CBP LOT 2-1A

EL PASO COUNTY, STATE OF COLORADO
GRADING & EROSION CONTROL PLAN

GRADING & EROSION CONTROL PLAN
CBP LOT 2-1A
JOB NO. 44-034
DATE PREPARED: JANUARY 2, 2019
DATE REVISED: MARCH 7, 2019

EL PASO COUNTY FILE NO. PPR 192

GRADING AND EROSION CONTROL NOTES:

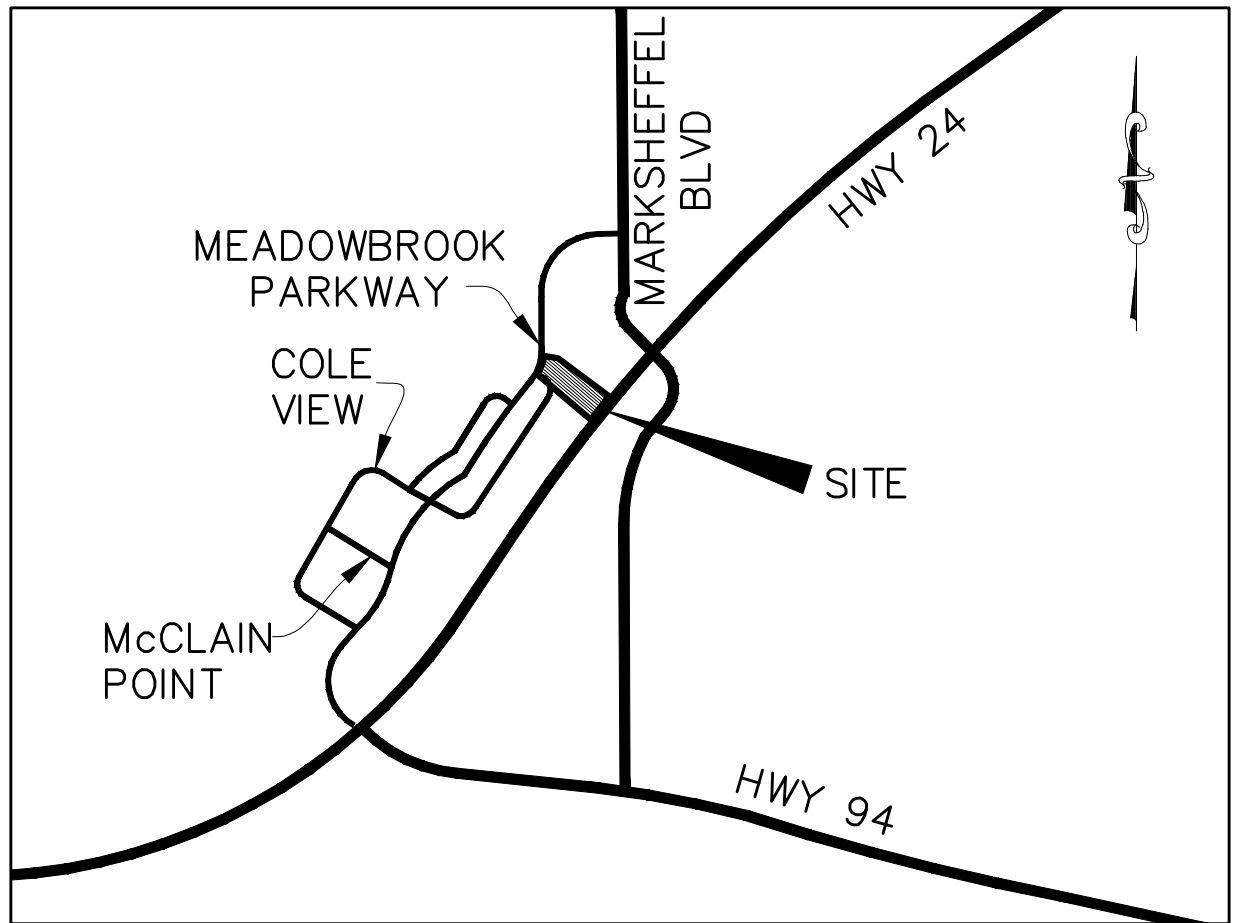
Please use the new
grading and erosion
control plan notes.
See attached.
